**Preliminary Alternative Technical Concepts (ATC) Submittal**  
**BEL-70-9.35 Interchange Improvement**  
**Design-Build**  
**Belmont County, Ohio**  
**PID 120547**

## Contents

# DRAFT MARATHON ACCESS FLOW

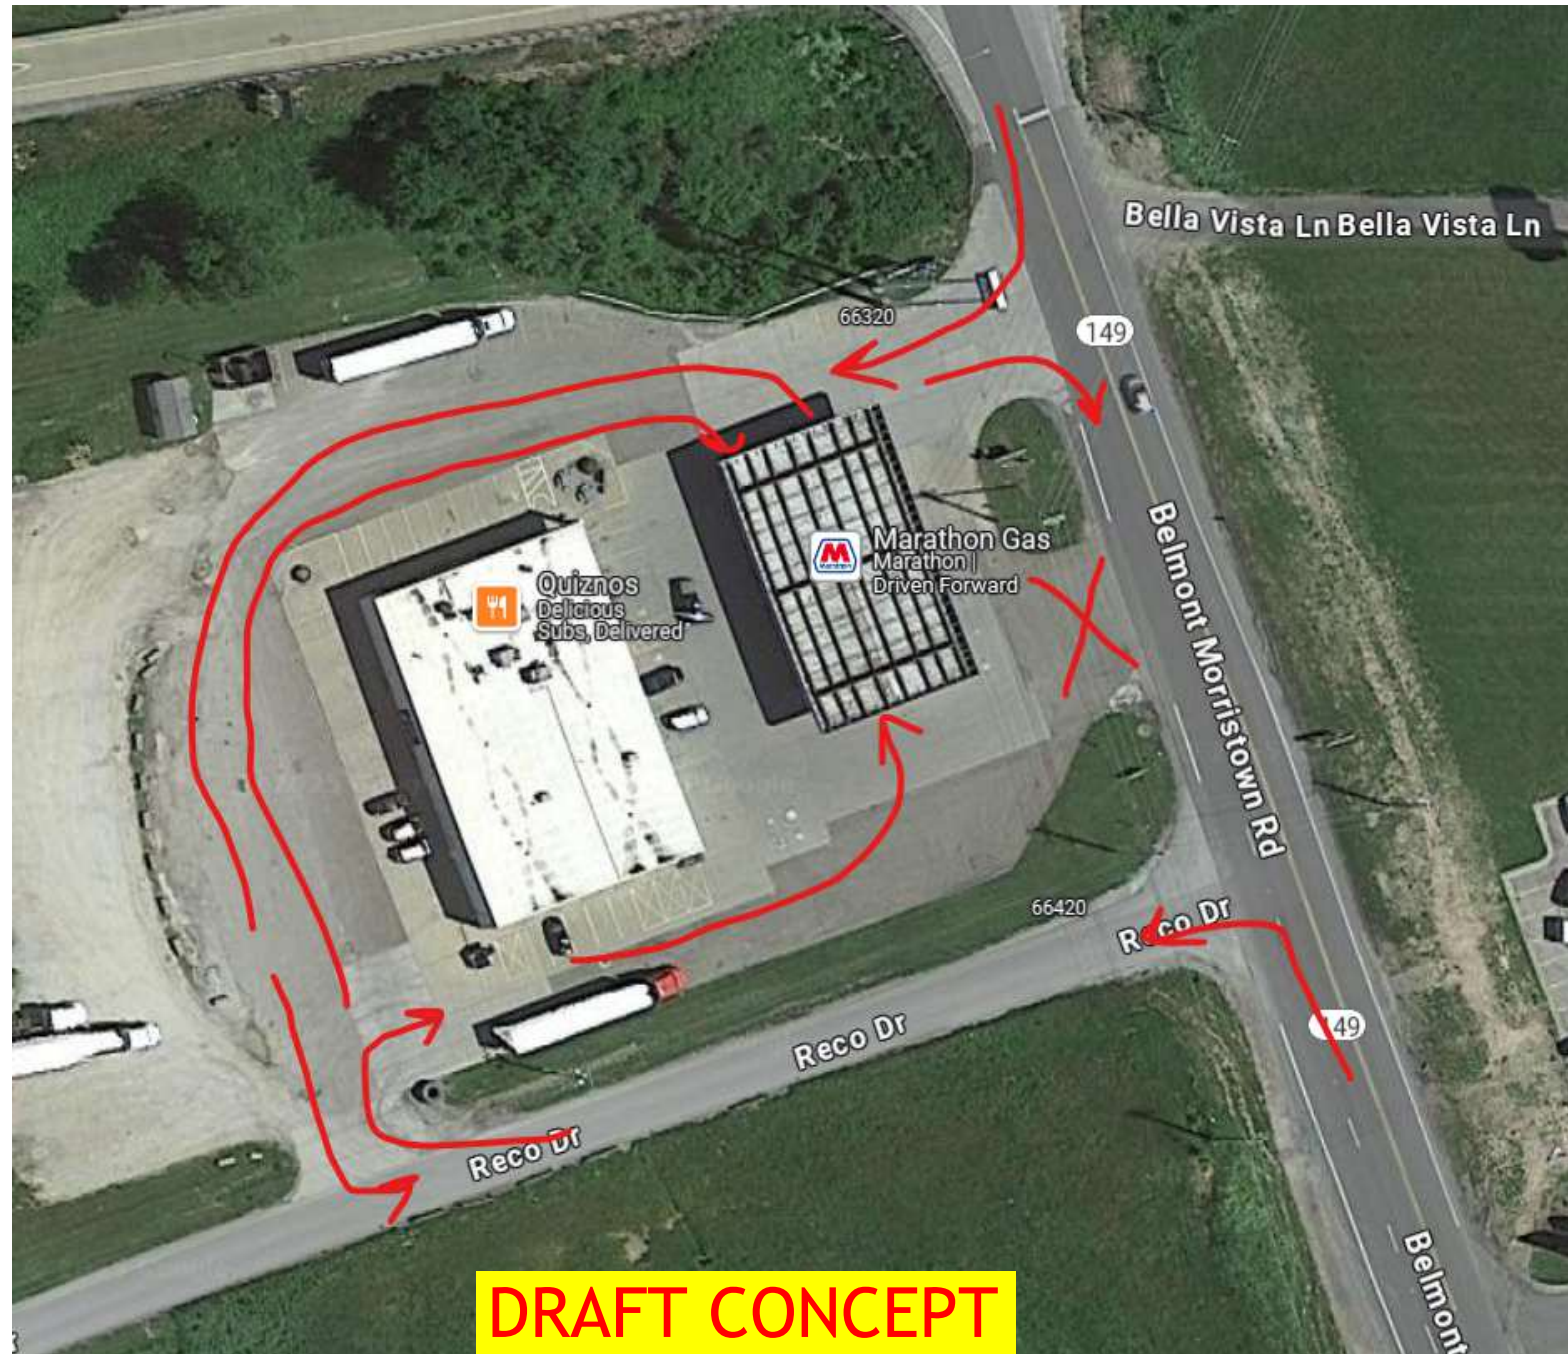
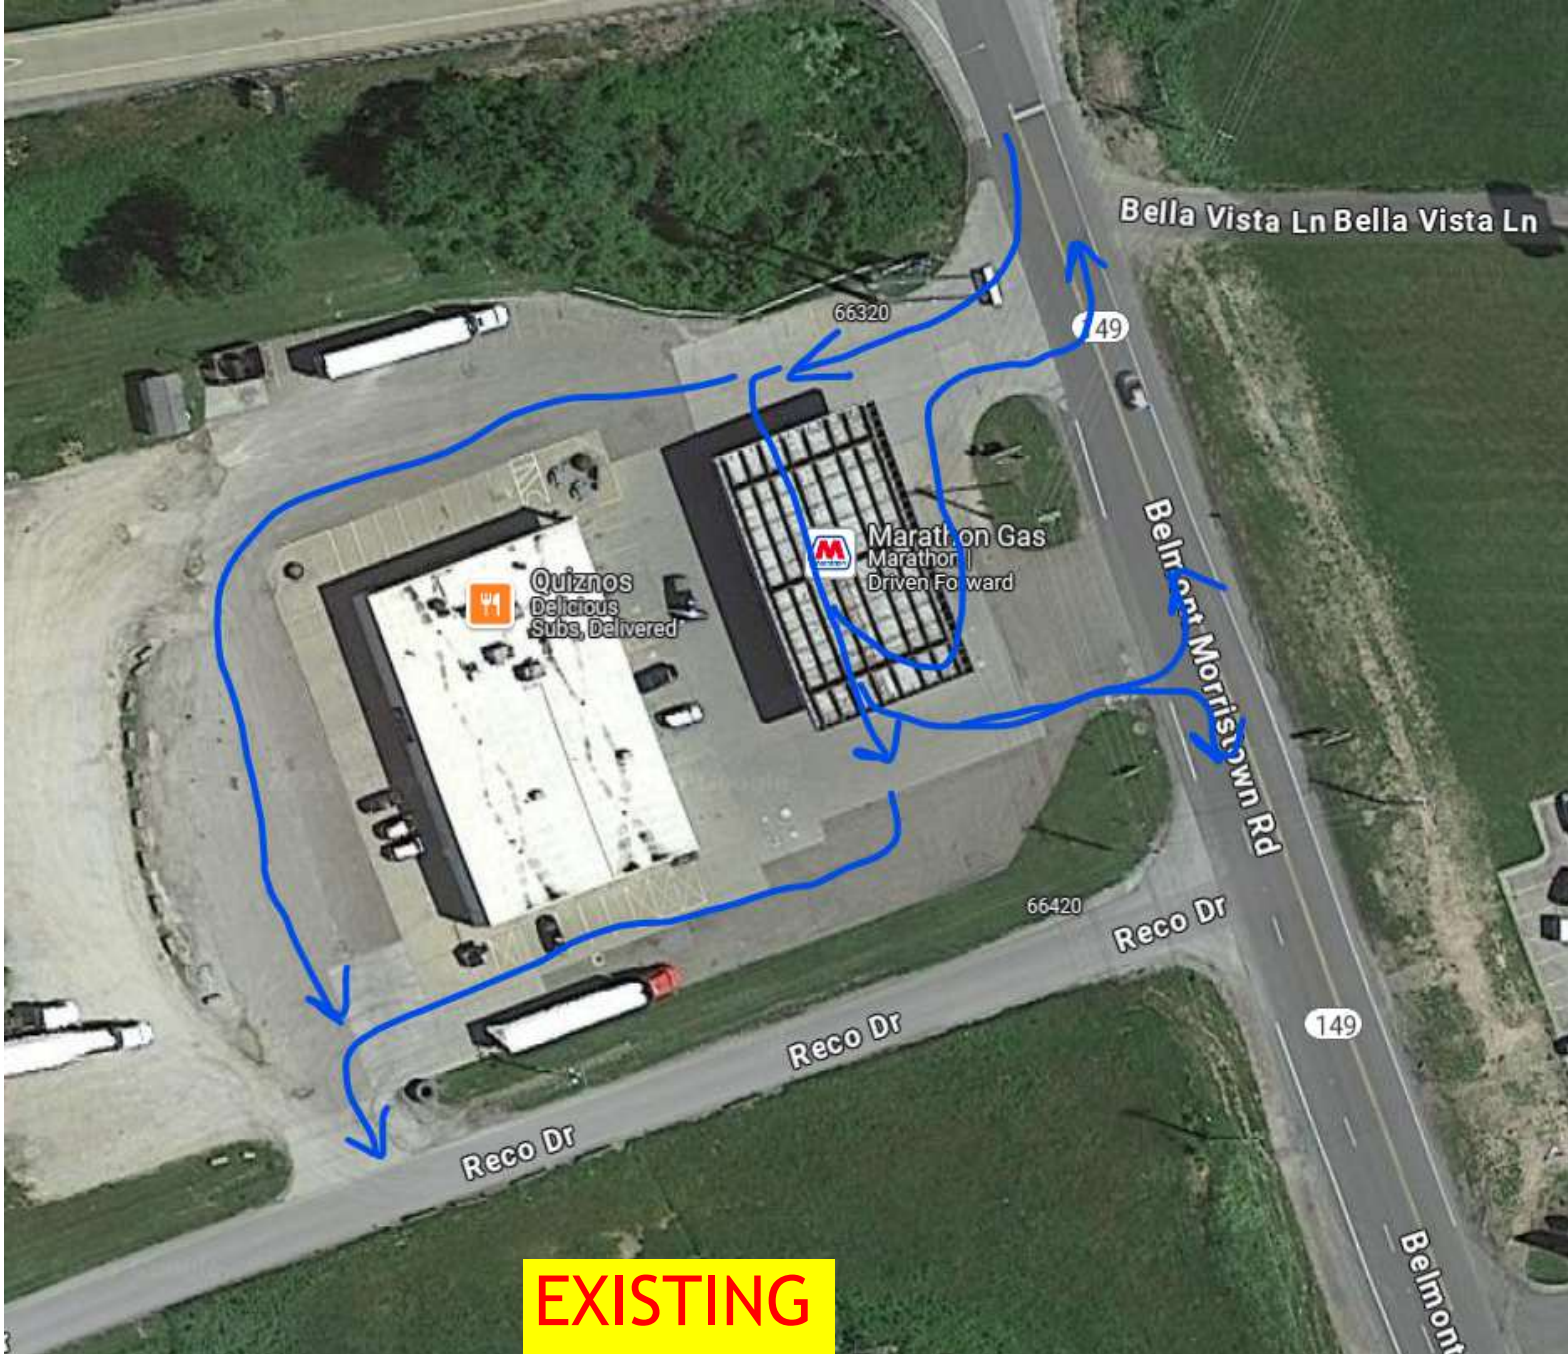
1. **Description:** This ATC proposes a modification to the driveway configuration requirements as outlined on Page 39 of 63 in the BEL-70-9.35, PID 120547 SCOPE OF SERVICES (Addendum 1). The original specification mandates that the DBT follow the geometrics depicted in the Conceptual Plans regarding proposed driveway configurations and existing driveway removals.

The DBT proposes to modify this requirement to design the driveways with input from the driveway owners. This modification allows for greater flexibility in aligning the existing Reco Drive with the new driveway configuration, rather than requiring a full realignment of Reco Drive. By working with local stakeholders to determine an optimal geometric design, this change aims to minimize construction impacts, reduce costs, and improve overall traffic flow while still maintaining functionality and accessibility for adjacent properties. See Exhibit E for additional details.

2. **Deviation:** Page 39 of 63 in the BEL-70-9.35, PID 120547 SCOPE OF SERVICES (Addendum 1) states: "*The DBT shall follow the geometrics depicted within the Conceptual Plans in regard to proposed driveway configurations and existing driveway removals.*"

The DBT proposes to modify the above language to: "*The DBT shall design Reco Drive to the ODOT Location and Design Manual Volume 1 and maintain a signalized intersection. The intersection point of Reco Drive and DR-2 shall be between Sta. 119+00 and 121+50. DR-3 and/or DR-5 may be eliminated, combined, or relocated by the DBT due to the proposed proximity to Reco Drive.*"

Exhibit F - ATC 13

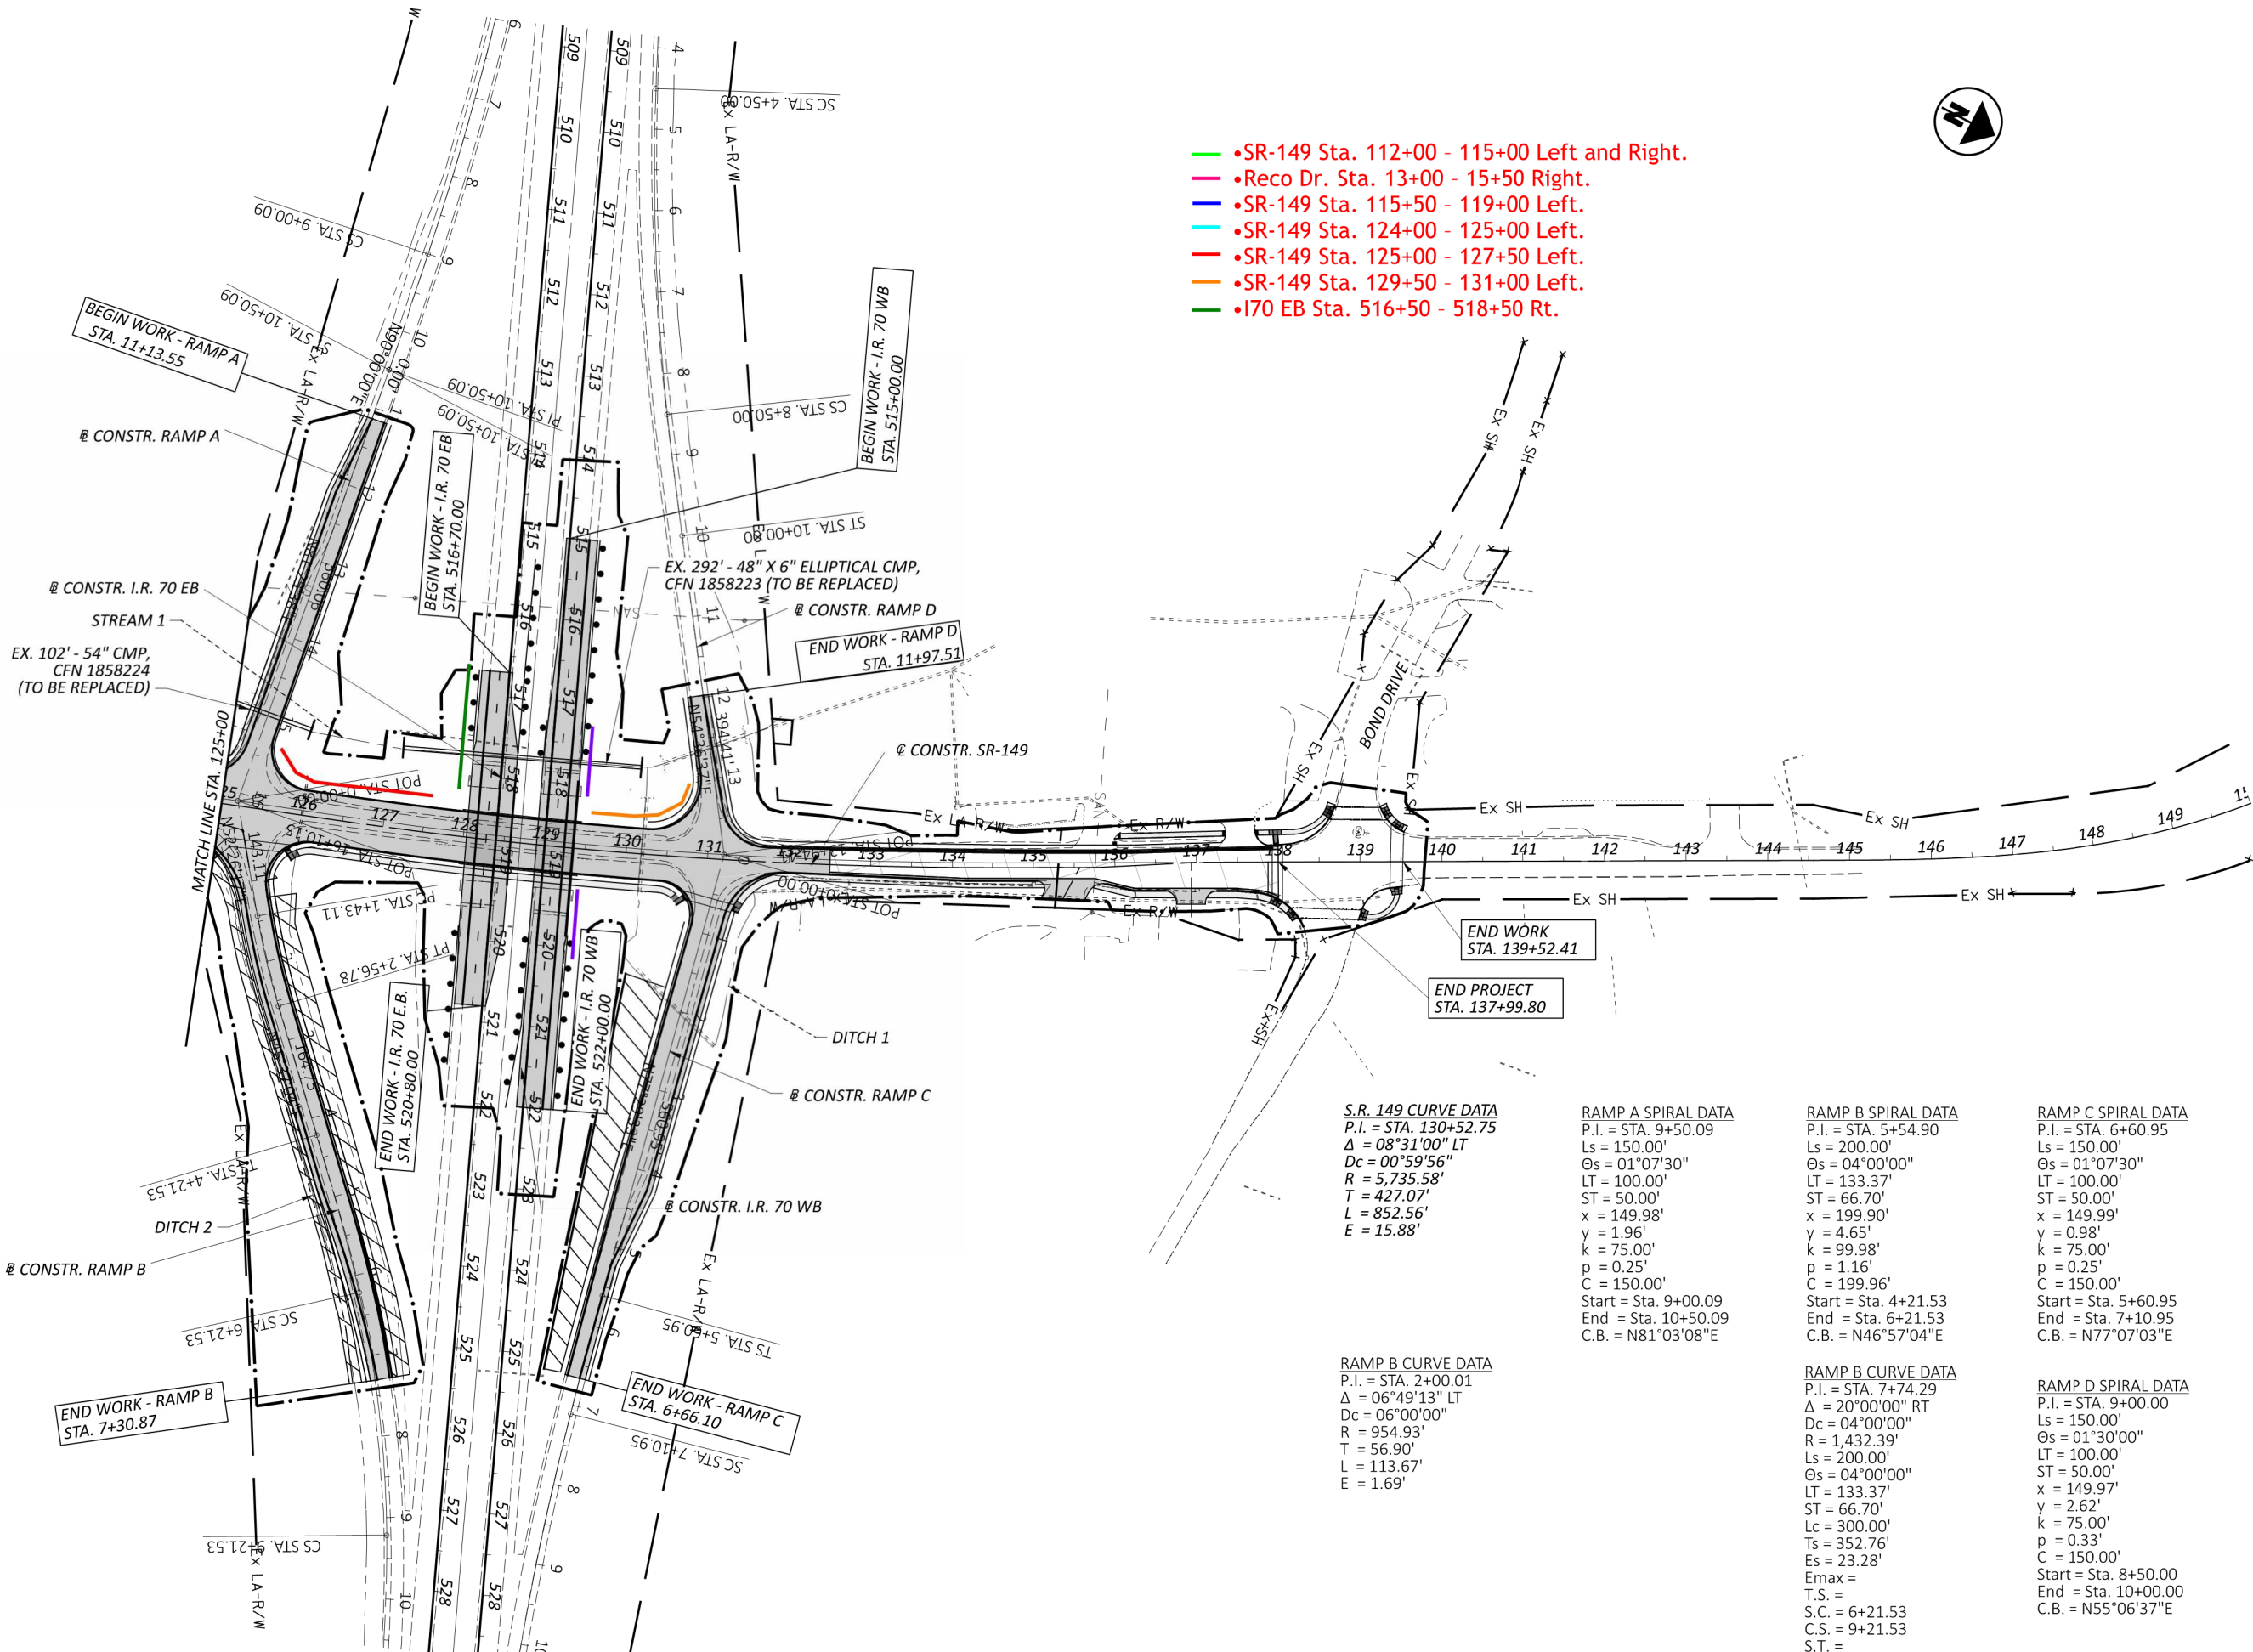
1. **Description:** This ATC proposes a change to the maximum side slopes specified Page 38 of 63 in the BEL-70-9.35, PID 120547 SCOPE OF SERVICES (Addendum 1) along IR-70 mainline, state routes, local roads, and ramps. Steeper slopes would minimize impacts to existing culverts, drainage, wetlands, or utilities. The use of steeper slopes is a sustainable solution that offers the following advantages over a precast or cast-in-place retaining wall option:

Our team may also implement combination 2H:1V on top of 1.5H:1V / 1H:1V slopes to minimize taller 1-1.5H:1V fills. See Exhibit F for additional details.

2. **Deviation:** Page 38 of 63 of BEL-70-9.35, PID 120547 SCOPE OF SERVICES (Addendum 1) states: "*The maximum side-slopes along SR-149, Reco Drive, and the ramps shall be 2:1. A 1.5:1 slope may be used only along IR-70 WB near the proposed approach slabs and bridge abutments.*"

The DBT proposes to modify the above language to: "*The maximum side-slopes along SR-149, Reco Drive, and the ramps shall be 2:1. A 1:5 slope may be used along IR-70 near the proposed approach slabs and bridge abutments, and a 1.5:1 slope at the following locations:*"

- SR-149 Sta. 112+00 - 115+00 Left and Right
- Reco Dr. Sta. 13+00 - 15+50 Right
- SR-149 Sta. 115+50 - 119+00 Left
- SR-149 Sta. 124+00 - 125+00 Left
- SR-149 Sta. 125+00 - 127+50 Left
- SR-149 Sta. 129+50 - 131+00 Left.
- I70 EB Sta. 516+50 - 518+50 Rt.

*1.5:1 may be steepened to 1:1 in locations above to minimize the impacts to existing culverts, drainage, wetlands, or utilities."*
